SAFETY EVALUATION REPORT

SOURCE MATERIAL LICENSE

WYOMING MINERAL CORPORATION

Docket No. 40-8502

FIGURE 2 WYOMING MINERAL CORPORATION ORGANIZATIONAL STRUCTURE

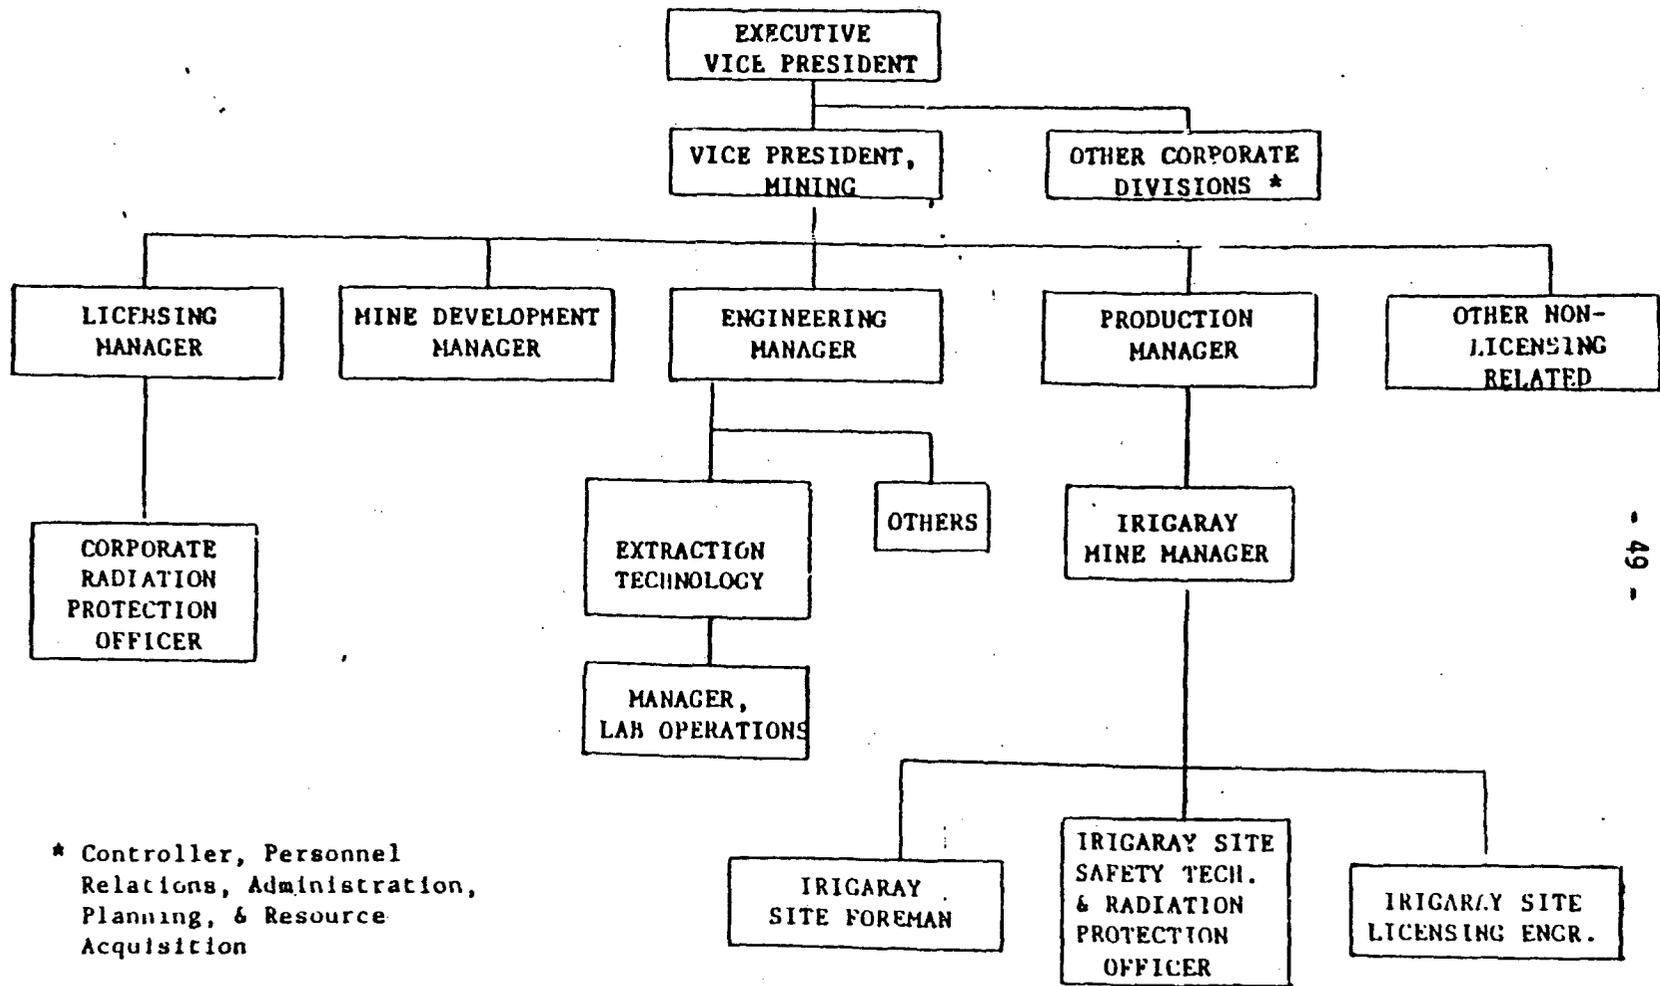
The WMC organizational structure delineating the lines of authority and operating responsibilities for pertinent radiological safety positions are shown in Figure 2.

The staff has determined that the organization and responsibilities of the various levels are satisfactory for the conduction of the solution mining operations in a responsive manner.
